County of Fairfax, Virginia

June 29, 2012

Re: Interpretation for RZ/FDP 2009-SU-024, PCA 2003-SU-035,
SEA 2003-SU-023, Dulles Discovery South, Tax Map 34-2 ((1)) 2 pt., 3A, 7, 8,
10A, 27 pt., 35 pt.: Building Addition, Building and Layout Modifications,
Road Improvements, Security, Landscaping and Parking

ATTACHMENT 4

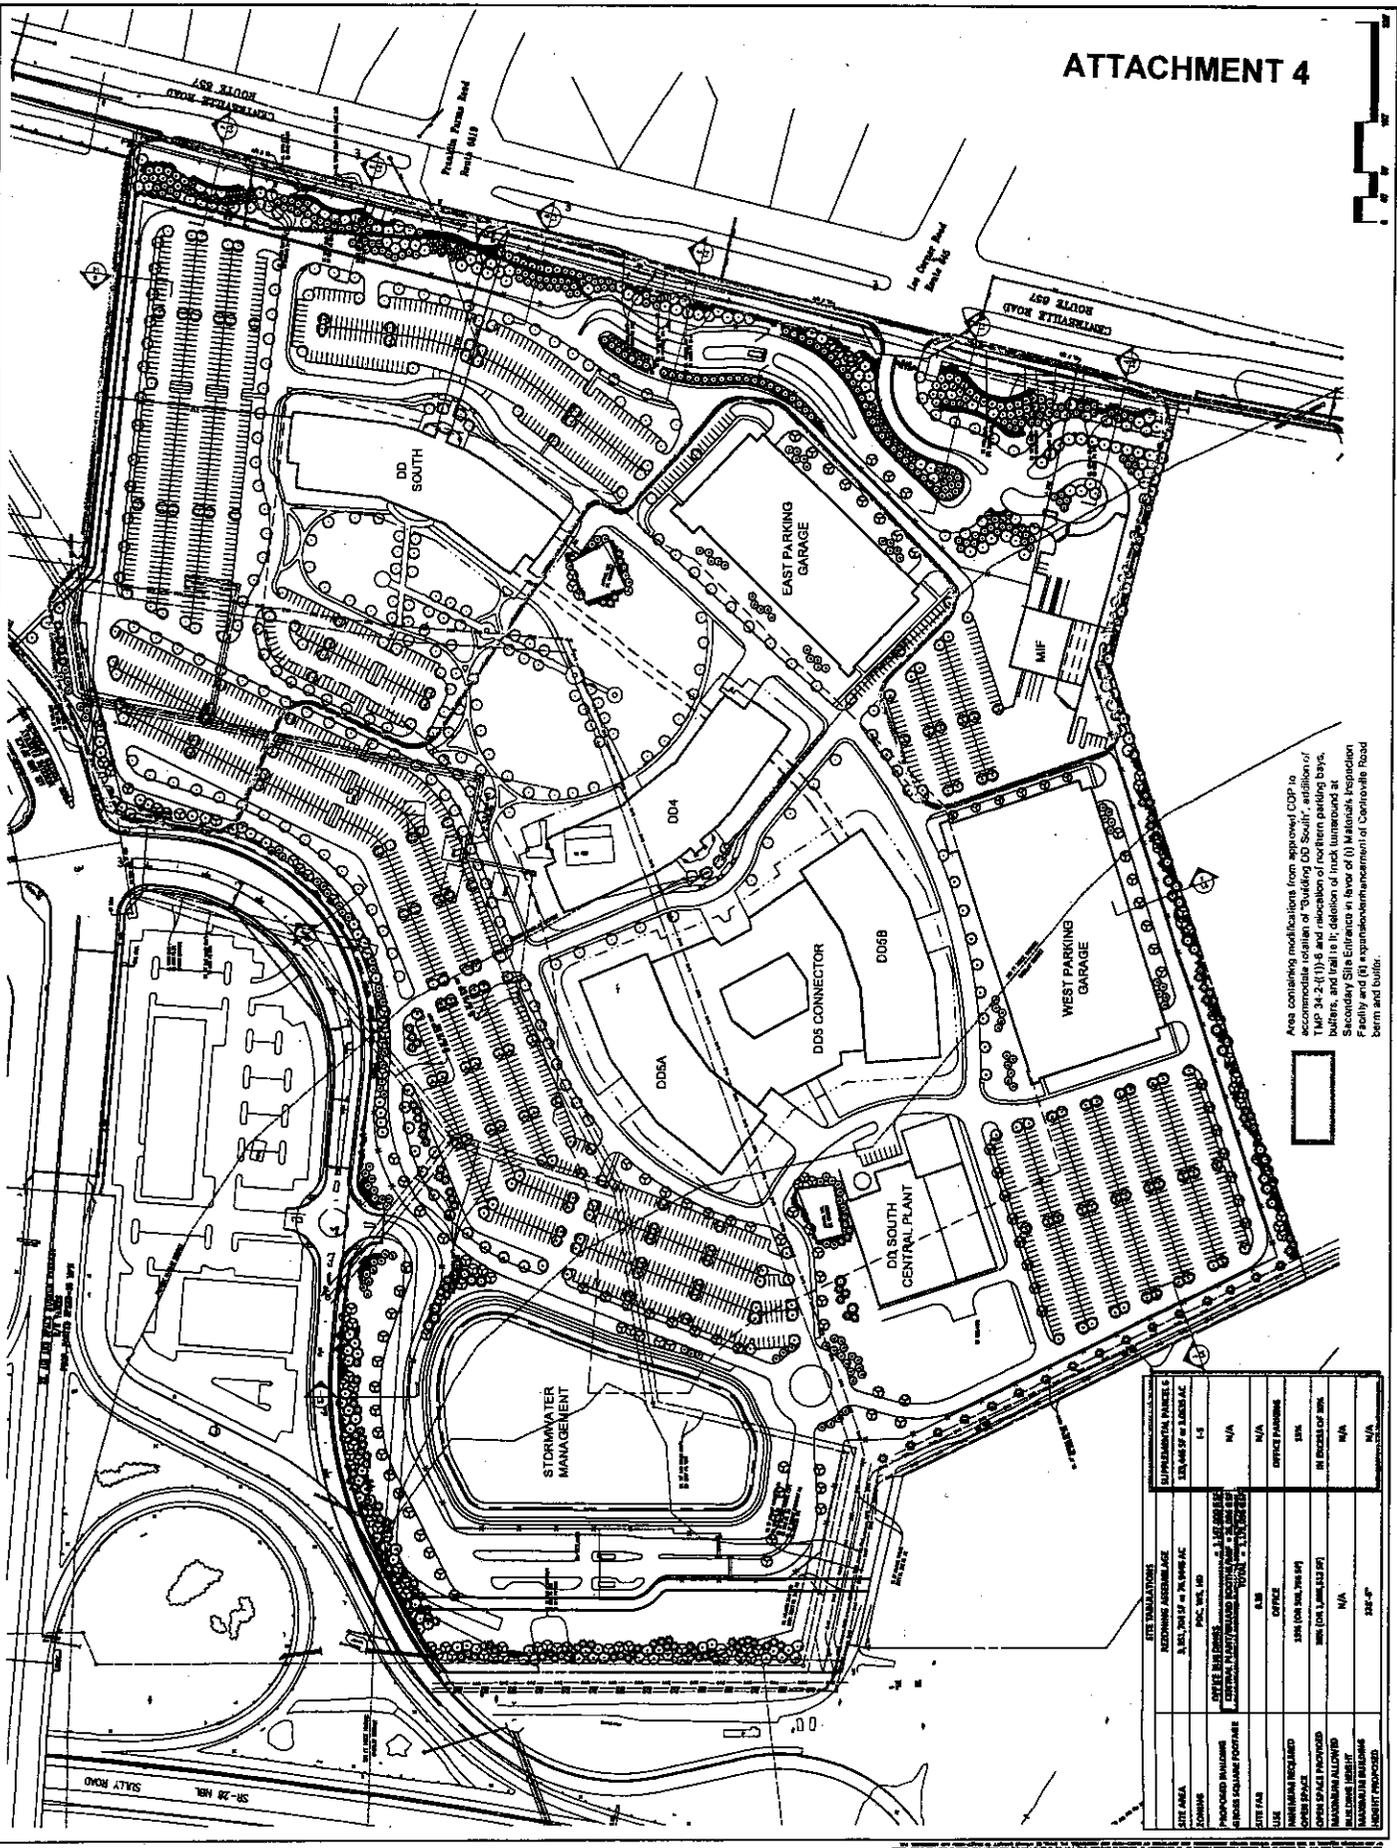
On March 18, 2011, in response to a prior proffer interpretation request, a determination was issued that the reorientation of Building DD South, the elimination of a truck turnaround and the addition of an accessory structure, depicted as a Material Inspections Facility (MIF), and the widening and enhancement of the transitional screening and buffer along Centreville Road, were in substantial conformance with the approved zoning. The MIF was indicated to include 8,100 square feet. In order to maintain the proffered FAR for the project, the GFA of the Central Plant was reduced by 8,100 square feet at that time.

Area containing modifications from approved COP to accommodate relocation of Building DD South, addition of TMP 3A-2-(1)-5 and relocation of northern parking bays, buffers, and trail is in; deletion of truck turnaround at Secondary Site Entrance in favor of (1) Materials Inspection Facility and (2) improvement/management of Centerville Road berm and buffer.

CAMPUS LOADING DOCK RENDERING
12.21.2011

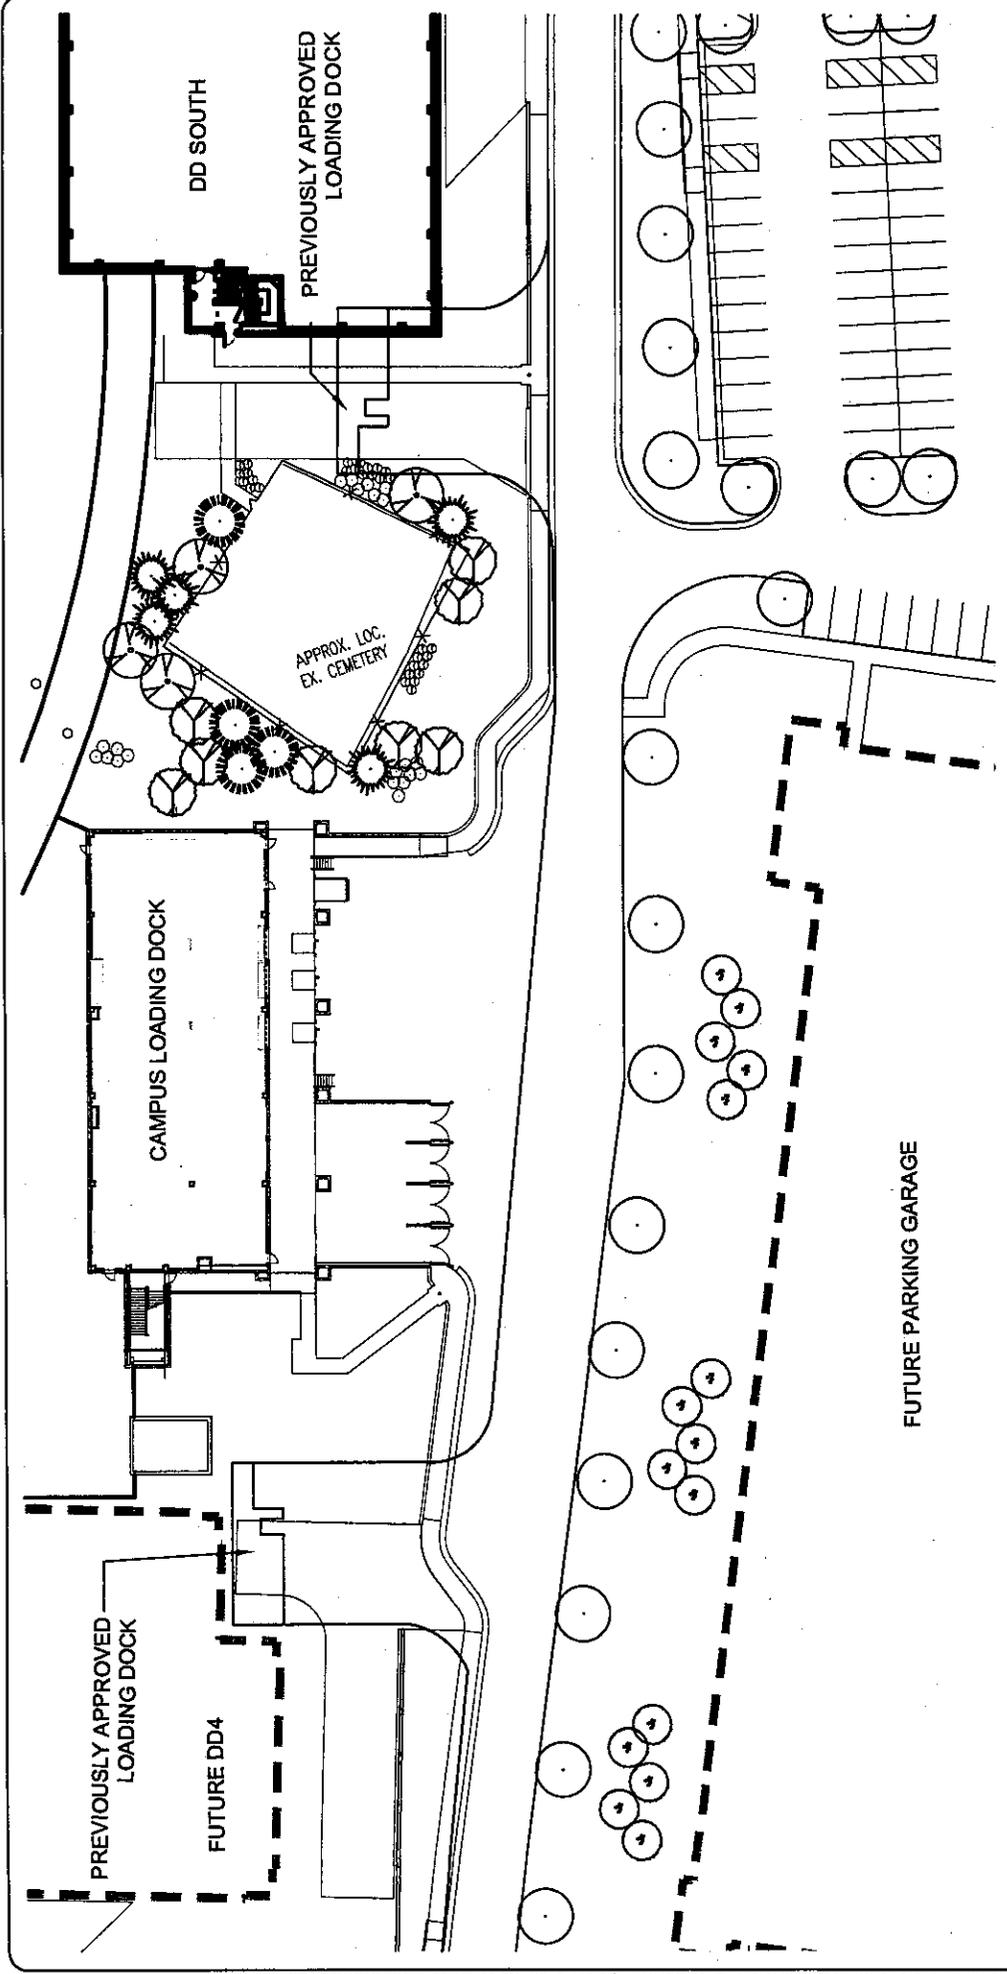
I. Central Loading Dock (CLD). The first question is whether the addition of a consolidated loading dock facility between Buildings DD South and DD4 would be in substantial conformance with the approved zoning. You indicate that the individual loading dock functions associated with Buildings DD South and DD 4 would be eliminated from the buildings, consolidated and relocated to the proposed structure shown on Attachment 5 of the submitted Interpretation Plan, as the Central Loading Dock (CLD). The CLD is proposed as a minor building addition, connected to the two buildings by an underground tunnel. The CLD would have the appearance of a separate building and would include 8,300 square feet of floor area above grade. The ground floor of the loading dock would be used for delivery vehicle inspection, staging, and loading, and is indicated to be 18 feet in height. Multiple cooling towers relocated from the roof of the DD South and DD4 office buildings would be located on the roof of the CLD. A parapet wall to screen the cooling towers and an architectural facade designed to appear as a second floor are shown in Attachment 6. This is an artificial facade extending from the building with no occupied space. The total proposed height of the CLD building would be 42 feet above grade.

As has been discussed in a series of meetings with you, Mr. Guinaw, Ms. Johnson, and others, the design change from the provision of separate loading docks for each building, as shown on the CDP/FDP, to a central CLD arises out of the tenant's experience at Dulles Discovery North and its recognition of the logistical and energy inefficiency of the CDP/FDP design. From the standpoint of security efficiency, consolidated and improved control of delivered materials, reduced manpower, more efficient delivery of both electrical power and cooling, and reduction of on-site mass, this proposed CLD represents a substantial enhancement of site design which will have no impact on any adjacent property and will substantially reduce the size of the Central Plant and the visibility of its profile from Historic Sully Way.

It is my determination that the proposed CLD building addition, the revised MIF, and the shifting of floor area from the Central Plant, as described above, would be in substantial conformance with the proffers, CDP/FDP, SEA Plat and development conditions, provided that the proposed cellar is designed, engineered and constructed to meet the definition of cellar, as determined by DPWES; provided that supplemental landscaping is installed around the foundation/perimeter of the CLD to soften the structure's appearance, and in the buffer along Centreville Road, if needed to adequately screen the CLD from Centreville Road, as determined by Urban Forest Management Division

DULLES DISCOVERY SOUTH
VIEW FROM PARKING LOT
MARCH 7, 2012

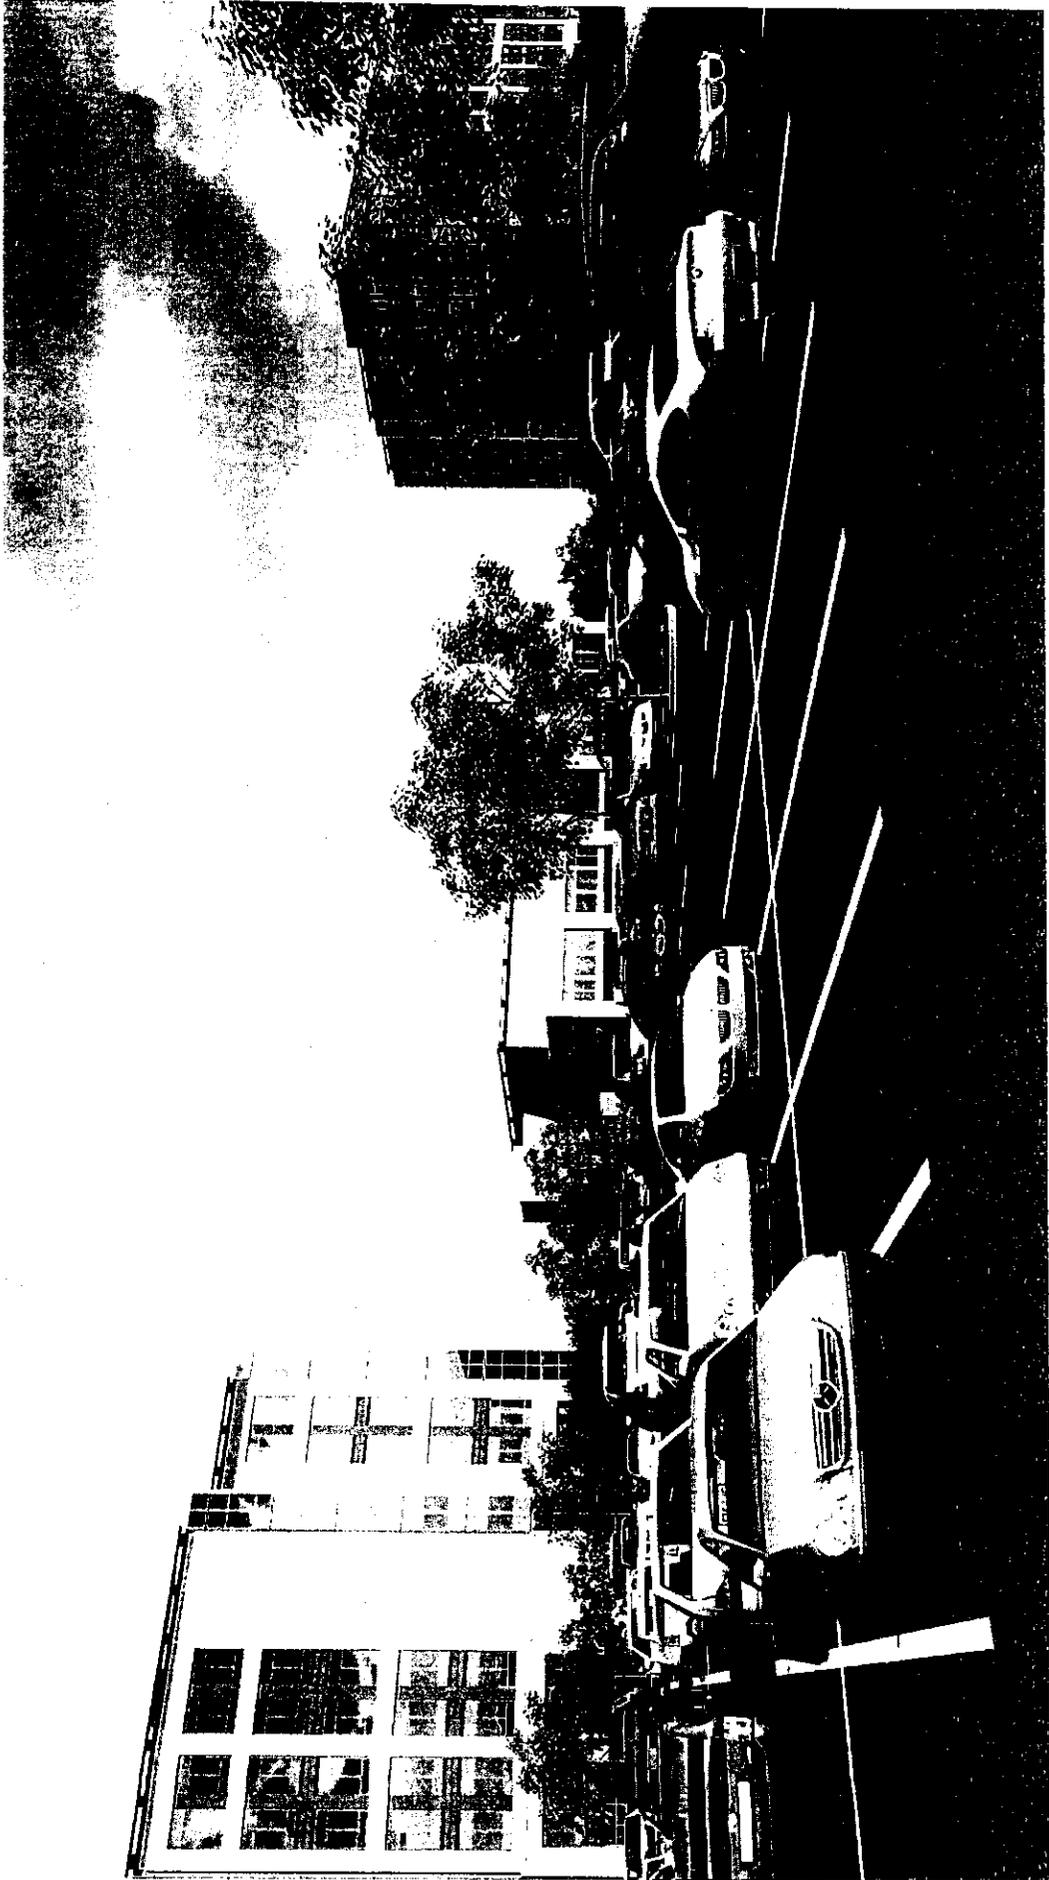
The proposed CLD would be located approximately 563 feet from Centreville Road. You indicate that the CLD would be screened by the future East Parking garage shown on the approved CDP/FDP, as illustrated in the sight line analysis in Attachment 7. However, construction of the parking garage is not planned at the present time. In the interim, prior to the construction of the garage, you indicate that the CLD would be screened to the east by the berming and landscaping approved as part of the March 2011 interpretation, as illustrated in Attachments 12A and 12B. No landscaping is shown in the interpretation exhibits around the foundation of the CLD.
